COMMONWEALTH OF MASSACHUSETTS
ENERGY FACILITIES SITING BOARD

)
)
) EFSB 90-100R
)
)

HIDDEN POWER: THE ELUSIVE CLEANER, CHEAPER ALTERNATIVES
TO THE
NEW BEDFORD COAL-FIRED POWER PLANT

Amicus Comments of the
Massachusetts Public Interest Research Group
(MASSPIRG)

EASTERN ENERGY VS. NATURAL GAS PLANTS

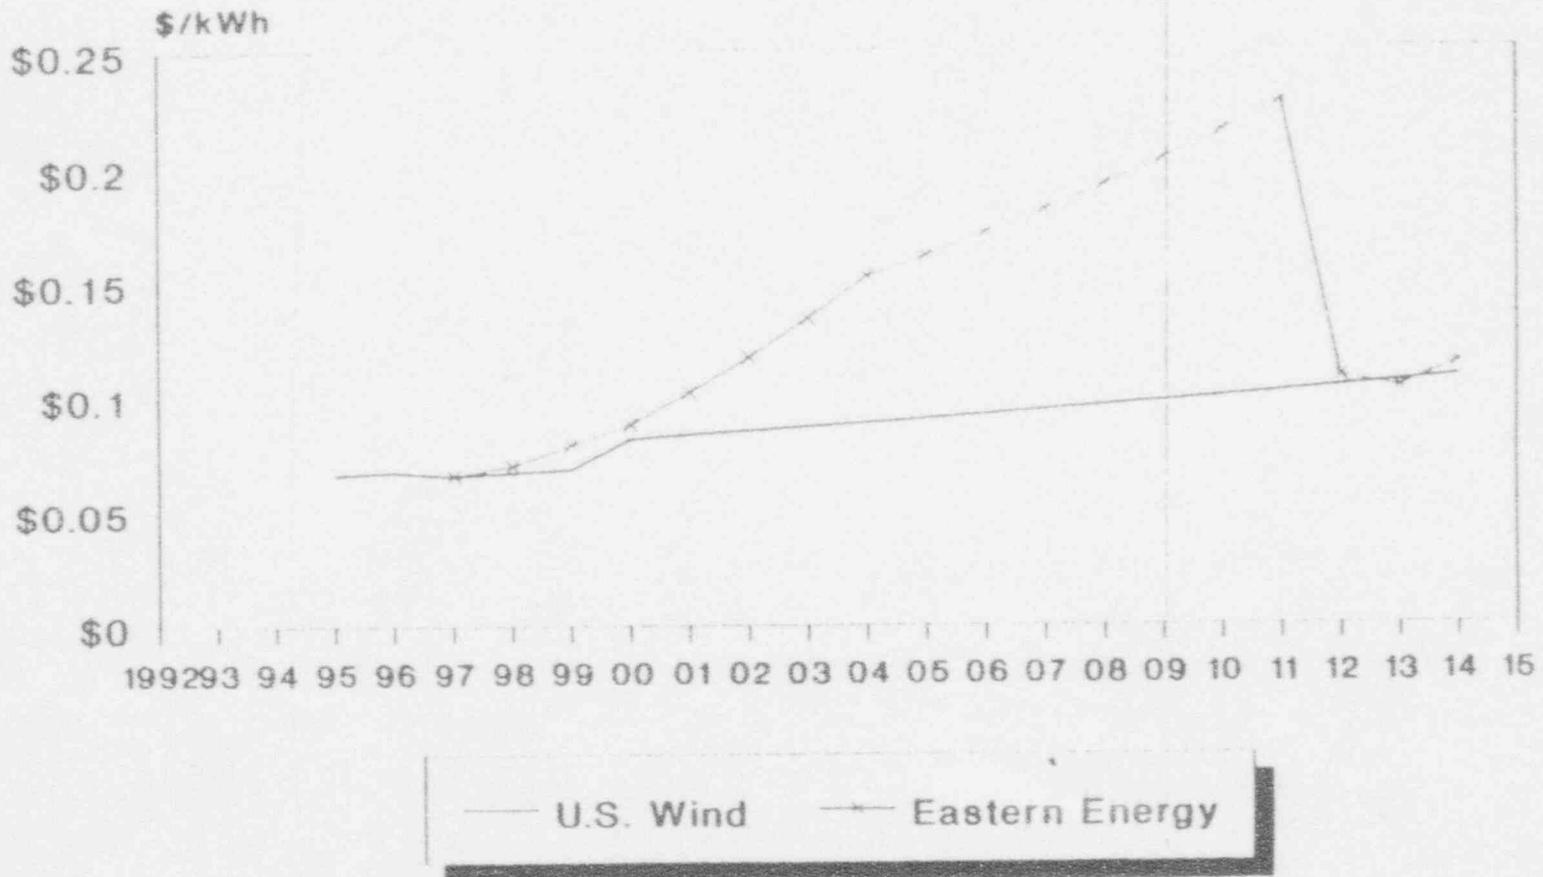
Attachment 1 presents a graph of the Eastern Energy contract¹ with Commonwealth Electric (DPU 91-234-A, Ex. MP-DSM-19), in comparison to contracts signed by Enron (Milford) with New England Power Company (Petition of Enron Power Enterprise Corp., Federal Energy Regulatory Commission, March 28, 1990); Altresco-Lynn and Commonwealth Electric (filed with the DPU on February 20, 1992, Supplemented February 21, 1992); a DLS Energy proposal to Boston Edison (DLS Energy, Inc., Petition to Intervene, DPU 92-130, June 1, 1992), and Boston Edison's proposed Edgar Energy Park (EFSC 90-12/12A). All of the gas plants are clearly lower cost than the Eastern Energy project.²

EASTERN ENERGY VS. U.S. WIND Contract Prices

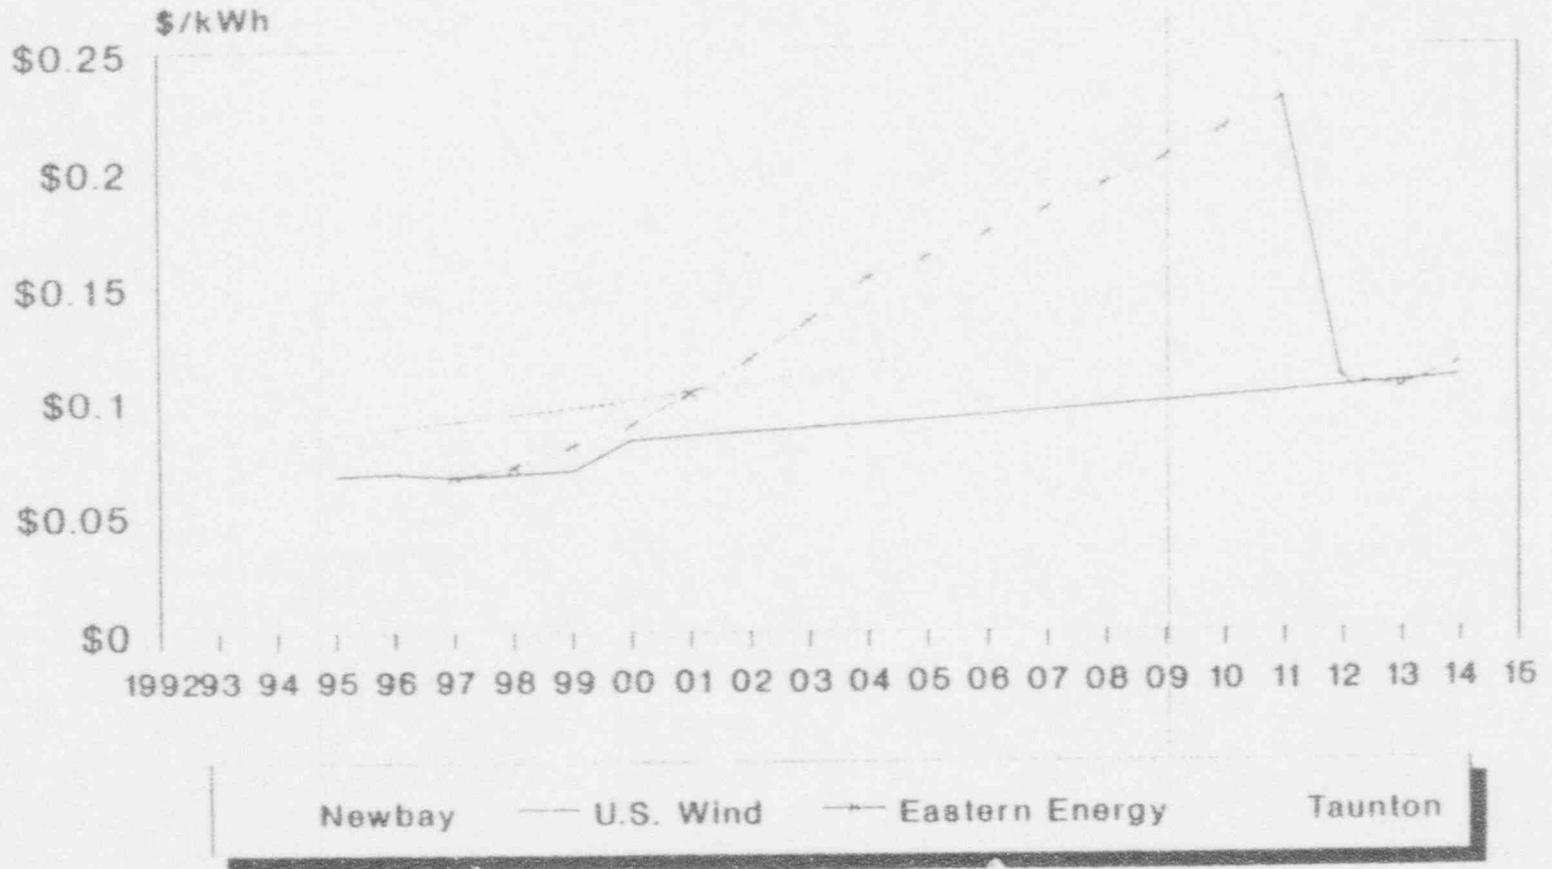
Attachment 2 illustrates the Eastern Energy/Commonwealth Electric price in comparison to the U.S. Windpower/New England Electric contract. ("Request for Approval of Contracts Executed as Part of the Companies' Renewable Resource Initiative," Volume 1: Contracts, U.S. Windpower, page 31) The wind plant has prices equal to or far below the price of the coal plant in every year of the contract lives, with zero emissions. Attachment 3 shows the contract prices of the two other coal plants the DPU/EFSC will be considering this fall, the Silver City plant in Taunton, and Newbay, in East Providence, Rhode Island, demonstrating that all three coal plants are significantly more expensive than the U.S. Windpower

ENERGY ALTERNATIVES

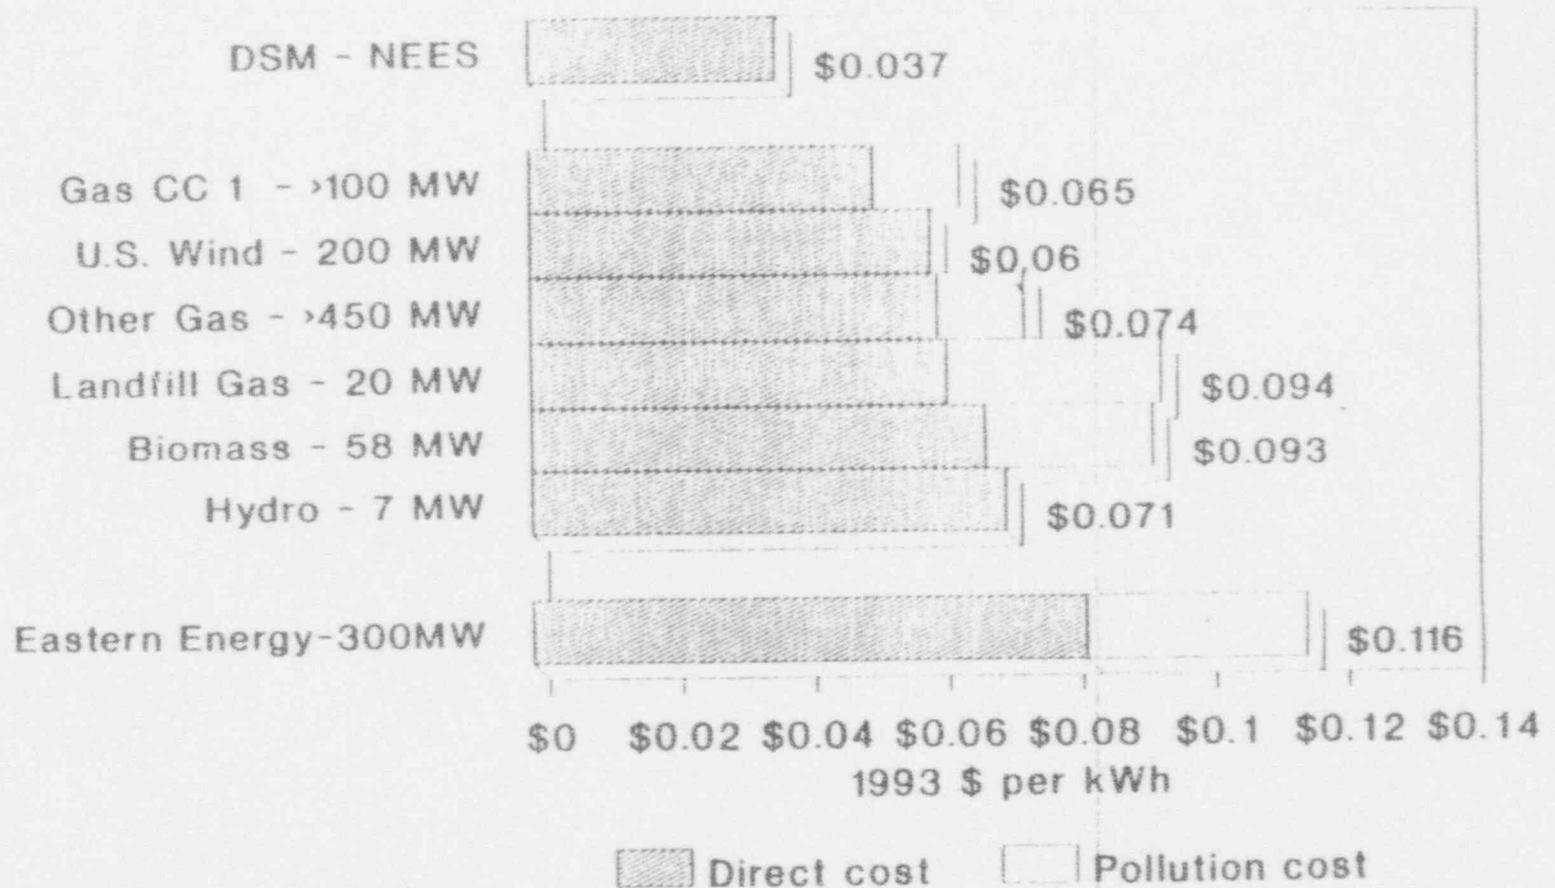
Attachment 4 illustrates the cost per kWh saved from NEES' 1993 DSM programs in comparison to real levelized prices of unsubscribed proposals from NEES' Green RFP, the state-of-the-art currently proposed natural gas combined-cycle plant, according to NEES, the above-mentioned natural-gas plants, and the Eastern Energy contract with Commonwealth Electric. Attachment 5 illustrates the cost per kWh of the same projects with the DPU's environmental externality values.²
